Comptex Bangladesh Ltd

Robintex (BD) Ltd

Vulta, Rupganj, Narayangonj, Bangladesh
(+23.772621N, 90.560453E)
17 May 2014

Observations

Column Strength – Comptex New Factory

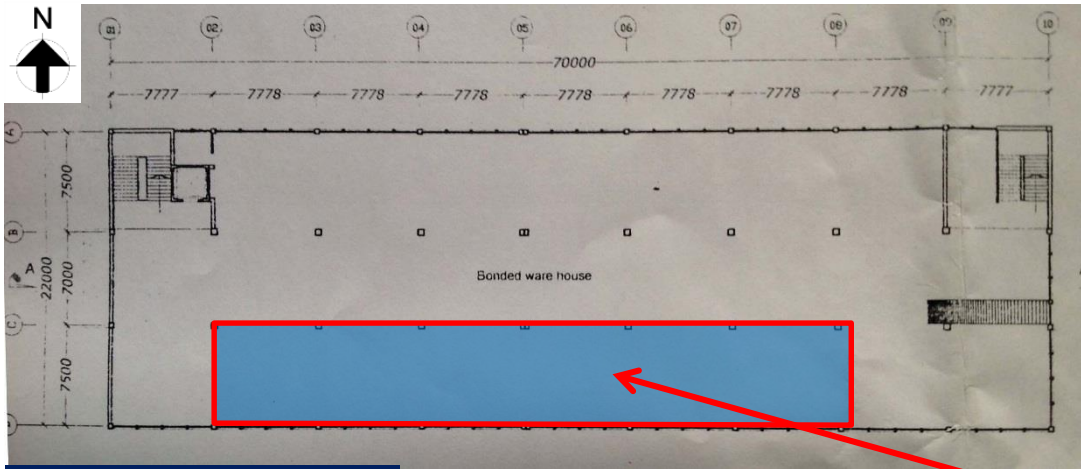
**Columns appear to be stressed to a
high level and require immediate
review**

Outline calculations indicate that columns are stressed to a high level and require immediate review.

Building Engineer to perform detailed calculations including a Detail Engineering Assessment (see attached scope) and concrete tests to prove adequacy of column sizes, and (if required):

- Reduce loads by vacating floors
- Reinforce columns

Cracking on soffit of ground floor slab

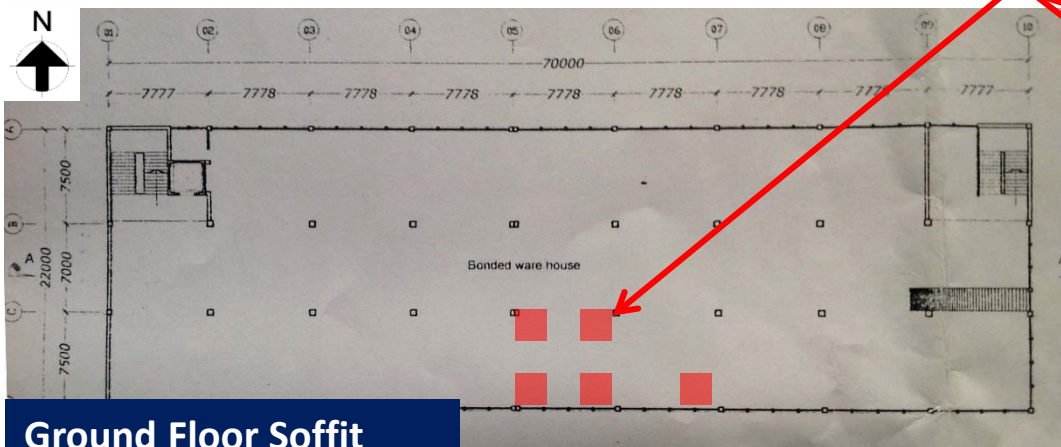
Cracking on ground floor slab soffit (particularly adjacent to building joint) was observed – including beam cracks. Building Engineer to review.

Stantar machines on ground floor – floor vibration noted

Cracking on soffit of ground floor slab

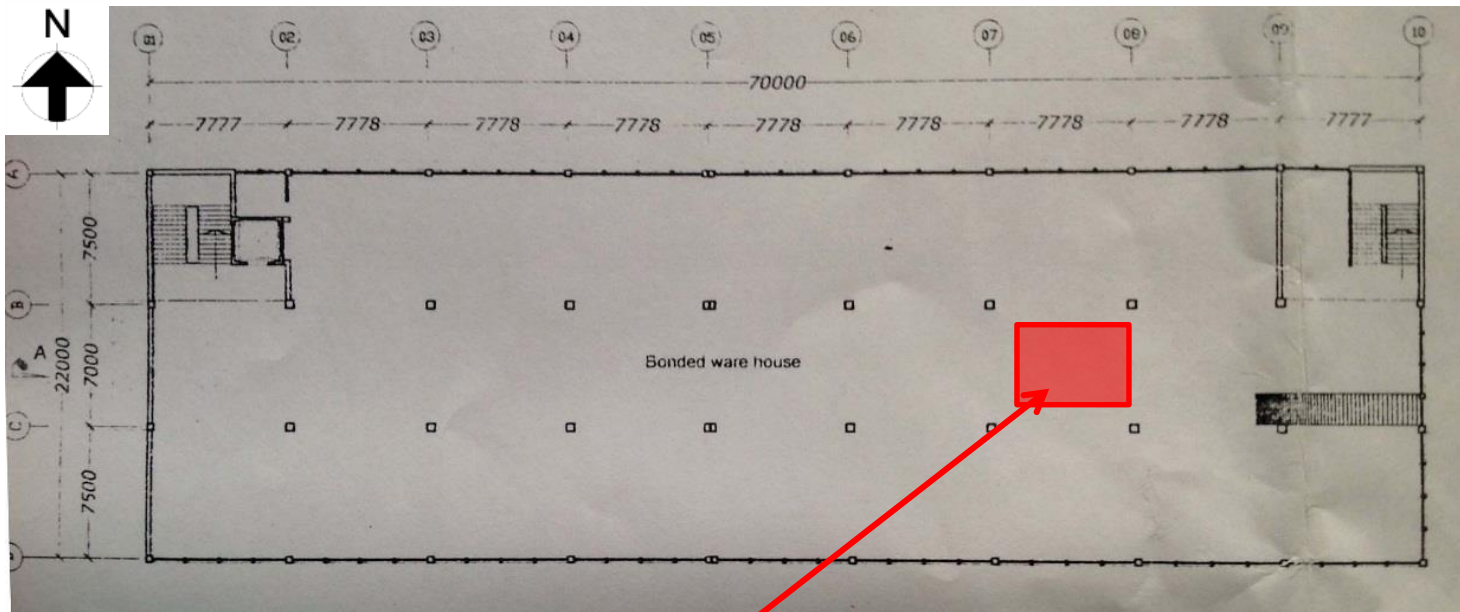
Crack Location

Ground Floor Soffit

Cracking on 3rd floor soffit

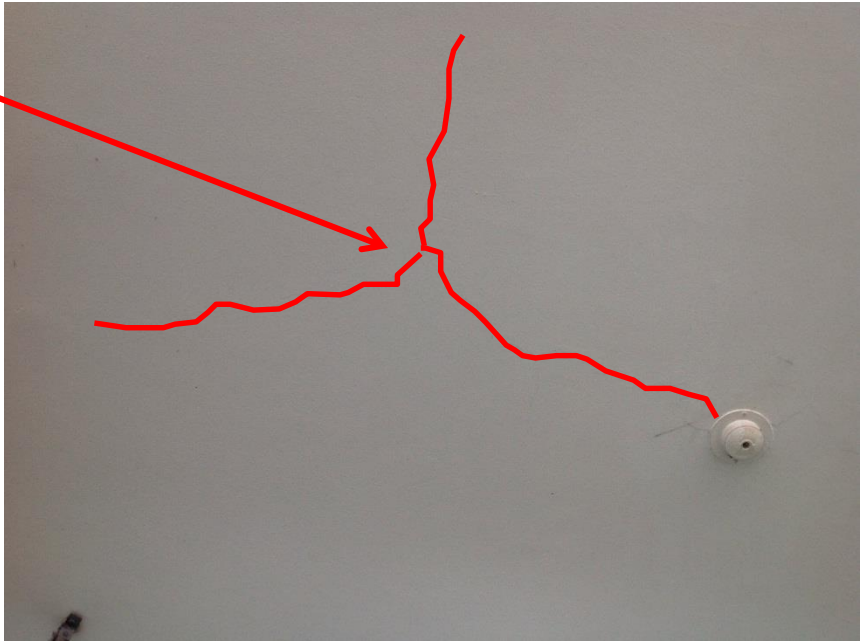
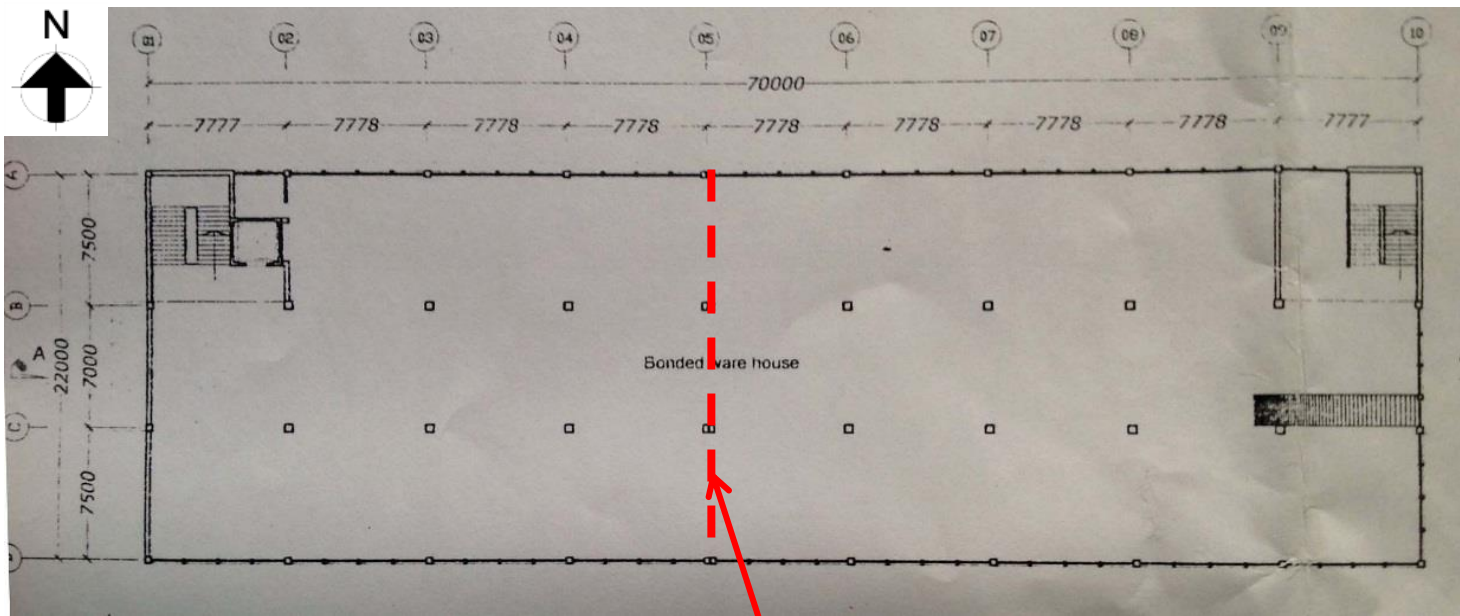
Crack on slab soffit

Evidence of slab cracks noted – Building Engineer to review if cracks penetrate to building structure

Building Joint

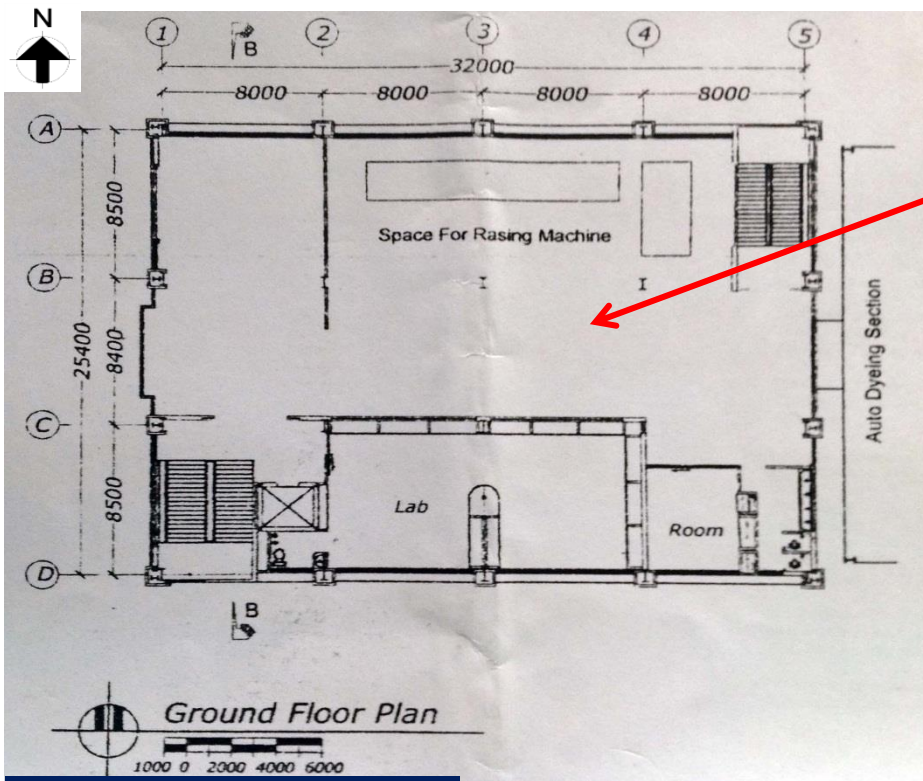
Cracked plasterwork at building movement joint

Some loose plasterwork at the building joint, particularly on the 2nd floor soffit, to be made good to avoid possibility of falling plaster at a future date.

Column Strength – Comptex Old Building

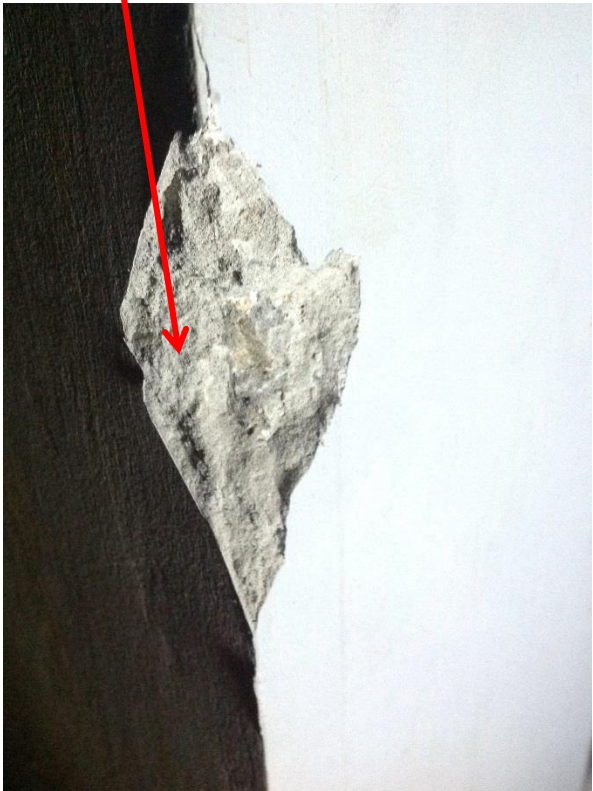
**Columns, within the basement,
appear to be stressed in excess of
normal design limits**

Cursory calculations indicate that column working stress, within the basement concrete columns, is in excess of normal design limits

Building Engineer is to perform detailed calculations and concrete tests to prove column size and (if required):

- Reduce loads by vacating floors
- Reinforce columns

Steelwork Defects

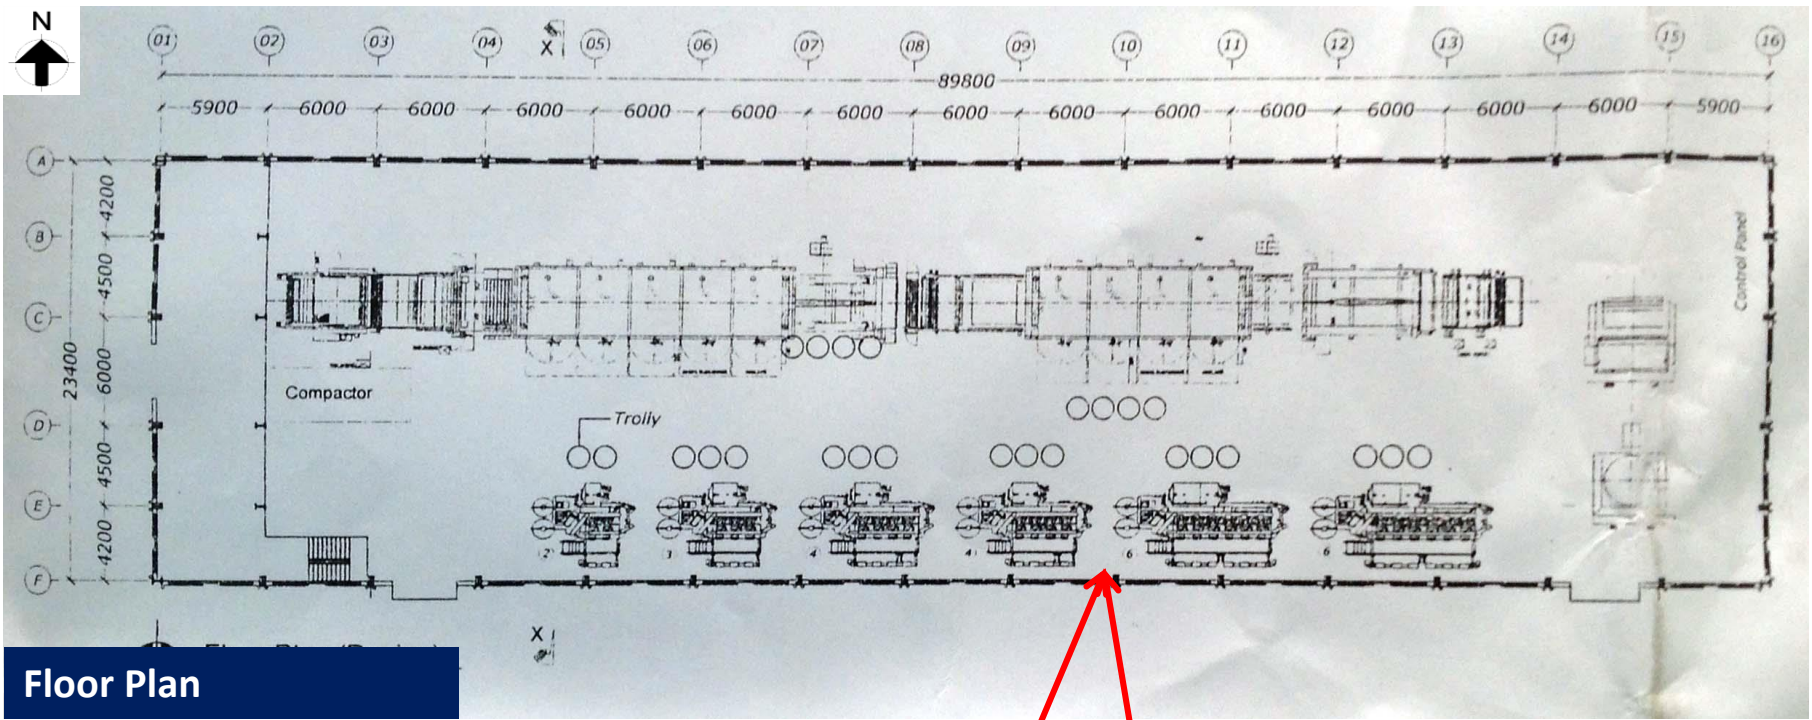
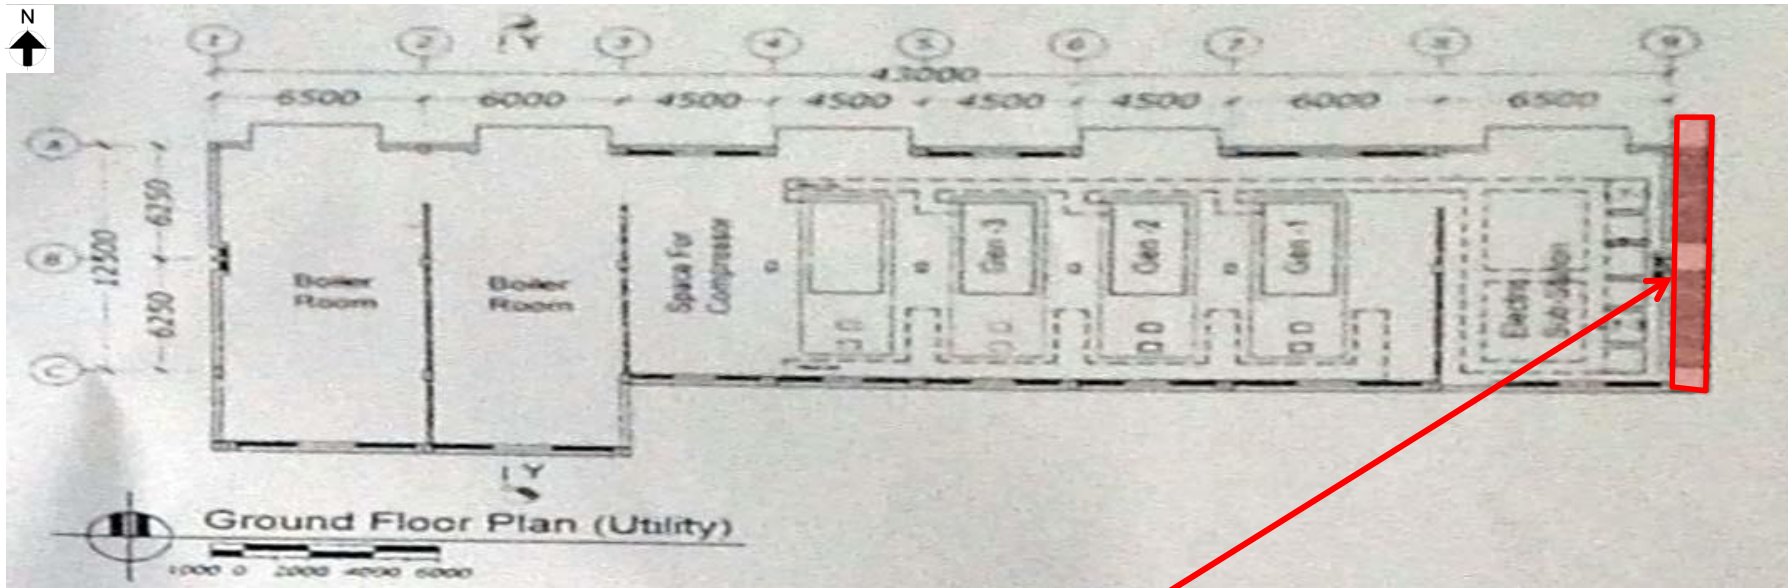
Damaged bracing and corrosion of structural steel sections

Corrosion of steel section

Damaged bracing to be reinstated

Missing flange restraints to roof steel rafters

Defective Handrail

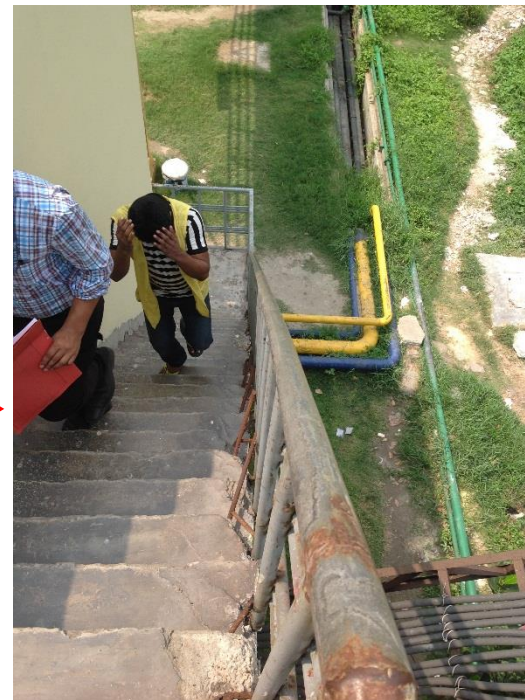
Defective handrail to a steep stairs, danger to people using it. Handrail and fixing to concrete to be reviewed by Building Engineer.

Utility Building – Basement Columns

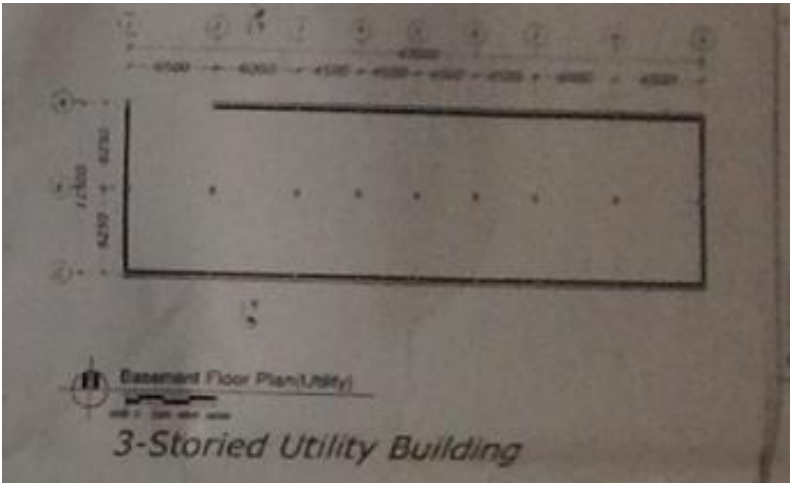
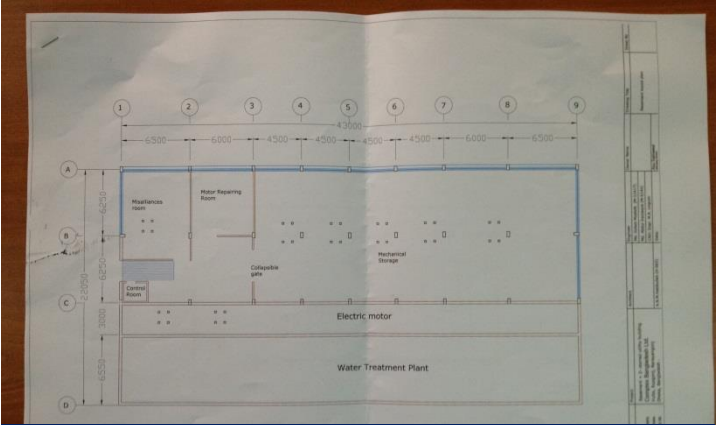
**Basement columns do not correspond
with structural drawings**

Utility Building Basement – original structural layout does not show equipment support columns

Utility Building Basement – updated Architectural layout showing equipment support columns.

Building Engineer to update basement column layout and prepare design verification calculations for equipment support columns.
